UNITED STATES
NUCLEAR REGULATORY COMMISSION
WASHINGTON, D. C. 20555

SUBJECT: INITIAL REVIEW AND RECOMMENDATIONS FOR SITE
SPECIFIC SPECTRA AT SEP SITES

Initial Review and Recommendations for Site Specific
Spectra at SEP Sites

Figure 6

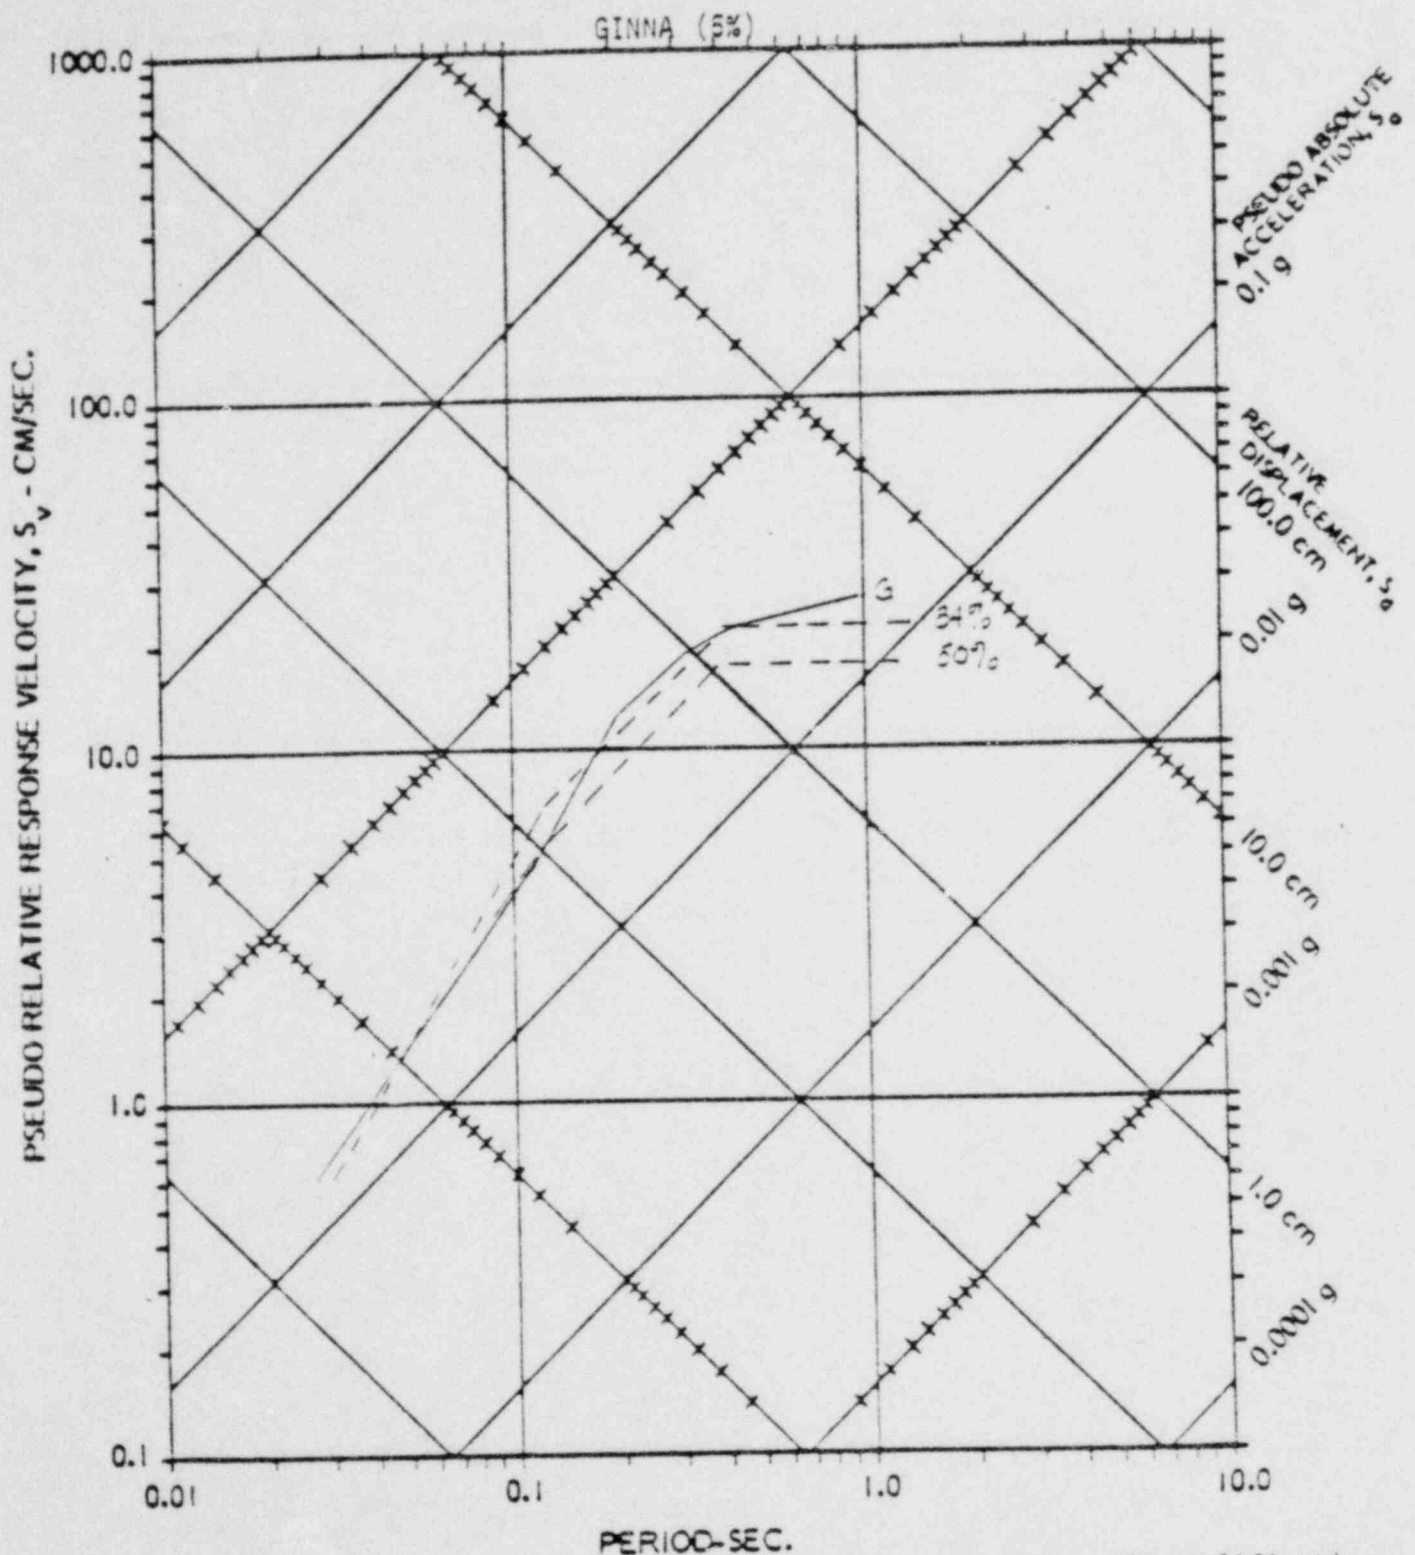
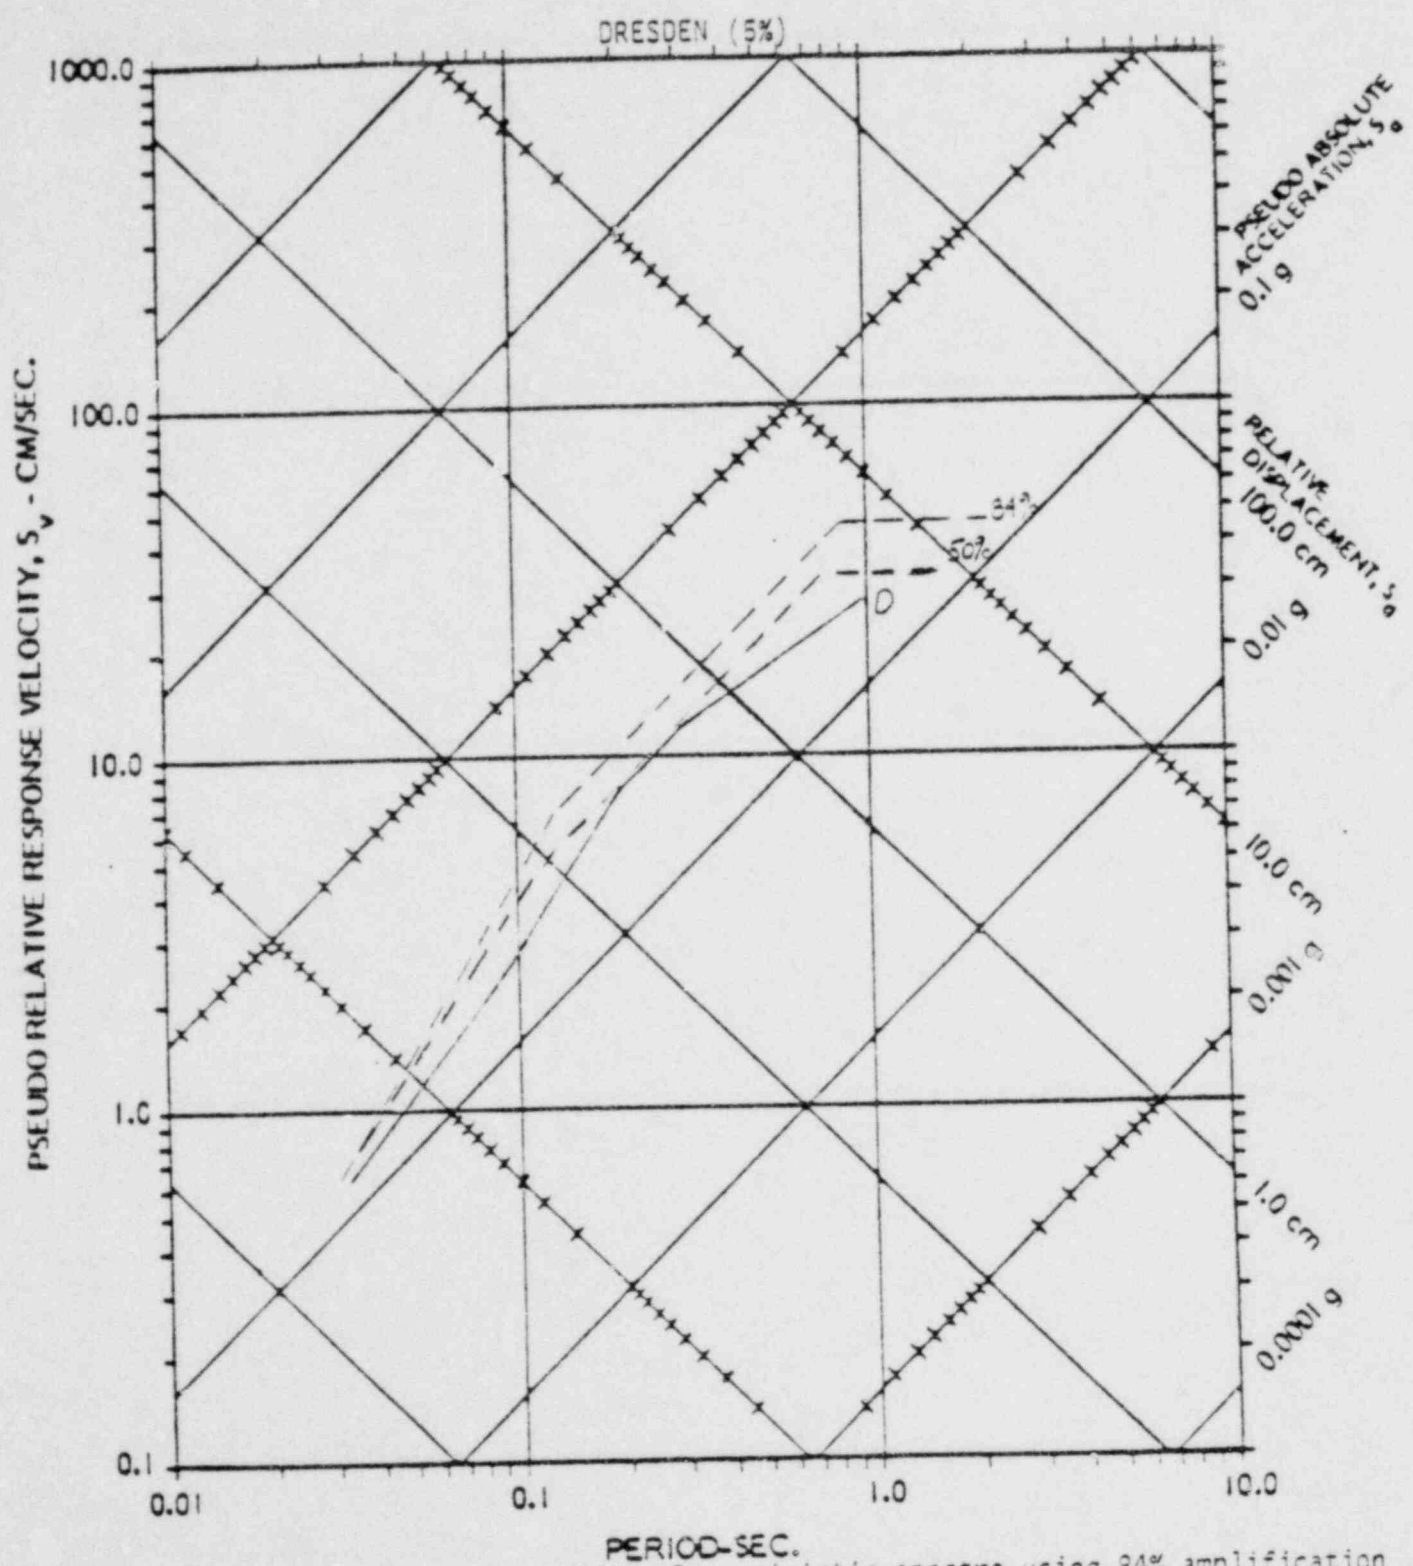
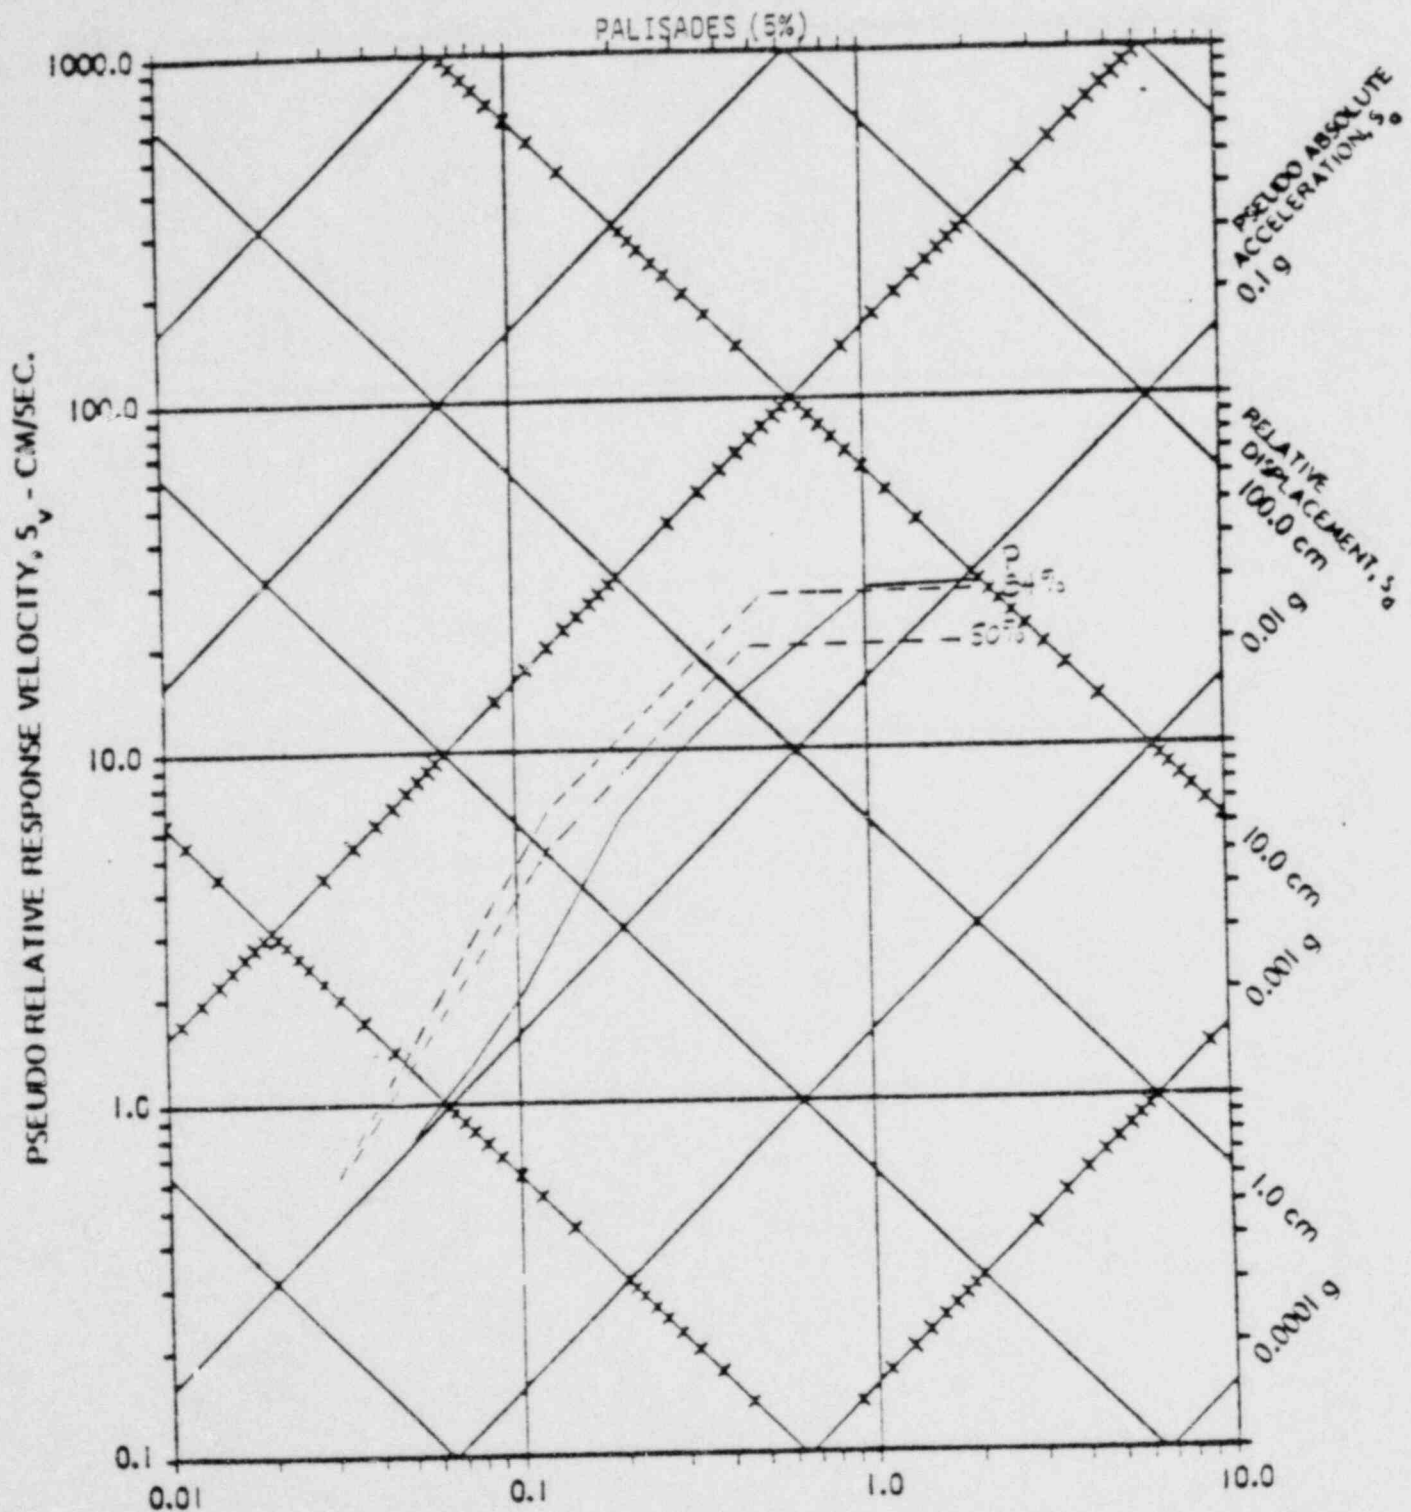
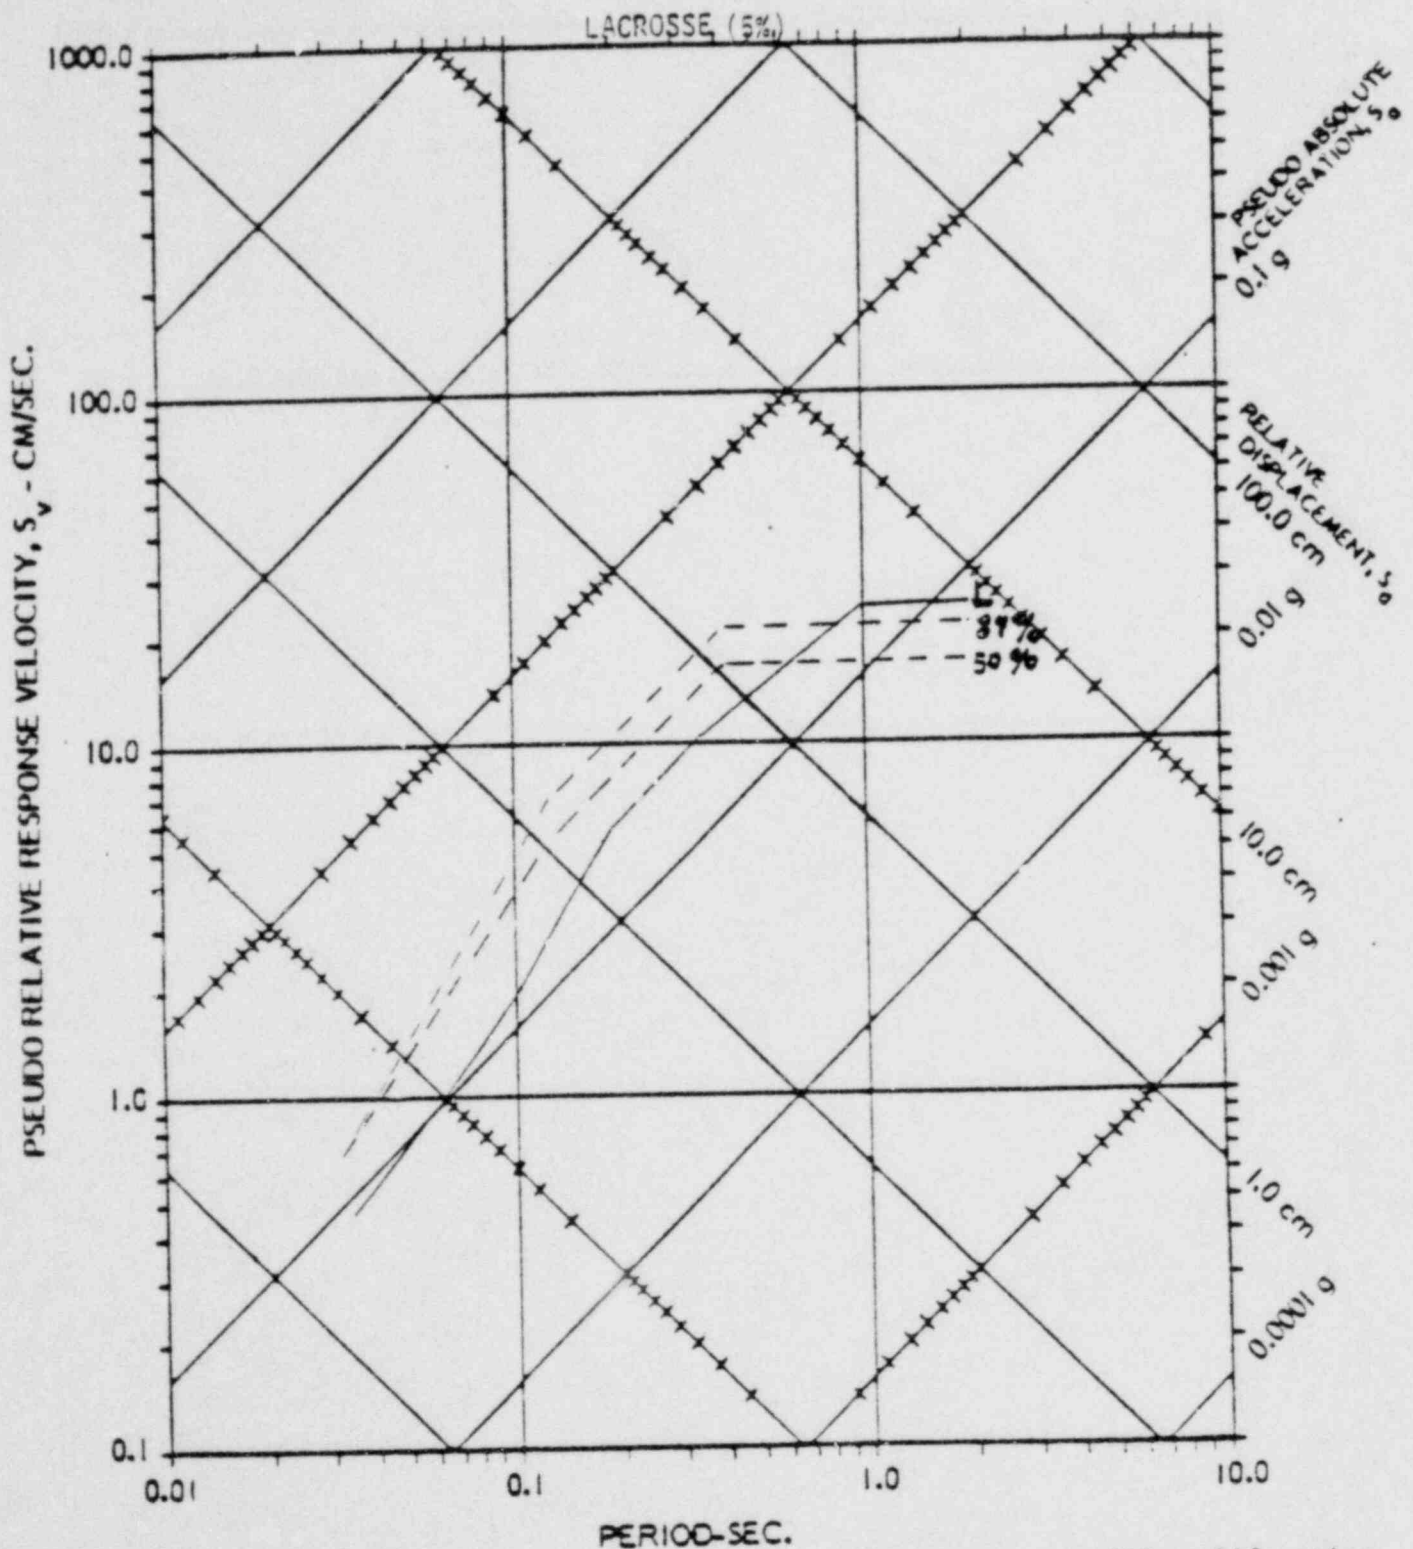
The deterministic peak accelerations and velocities are converted to response spectra using the amplification factors suggested by Newmark and Hall in NUREG CR-0098. Figs. 3 thru 11 compare the recommended uniform hazard spectra with 50th and 84th percentile deterministic spectra. In the central U.S. the recommended spectra generally fall below or at the 50th percentile. In the eastern United States the uniform hazard spectra are approximately

equivalent to the 84th percentile deterministic spectra. While the deterministic peaks are generally lower than the predicted peaks, use of the 84th percentile amplification factors usually more than compensate for the differences. Again the uniform hazard spectra more adequately reflect perceived relative hazard. The "tectonic province" approach can be made to achieve conservatism in this case by utilizing conservative amplification factors.
